LLOYD'S REGISTER OF SHIPPING.

the Owners Representative, Survey the Steel Screw Motor Tanker "O N D I N A" of Willemstad 6341 Gross Registered Tons, for the purpose of (1) ascertaining the nature and extent of damage which is stated to have been caused by shells and torpedoes during enemy action in November 1942, while the vessel was on a voyage from Fremantle to Overseas Port, and (2) recommending necessary repairs. It is stated that, after the action, the vessel returned to Fremantle under her own power.

M.T. "ONDINA" AT FREMANTLE 14th JUNE 1943.

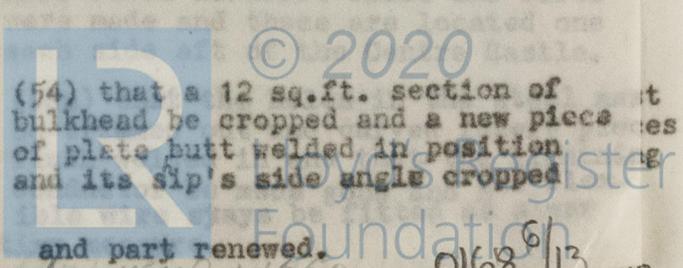
'S SIDE (STARBOARD) DE-3 STARBOARD TANK AND THE P ROOM. Plate below sheer's twin shell holes similar in Starboard Bow plating res approximately 4 ft. each side of the bulkhead Pump Room and No.3 Starboard. Two horizontal members boom on ship's side torn in hole.

(53) release plate at a rivetted joint and crop at a position forward of the damage and rivet and butt weld and strap a new piece of plate approximately 10 ft. long by 5 ft. wide by 5/8" and fit two new horizontal members.
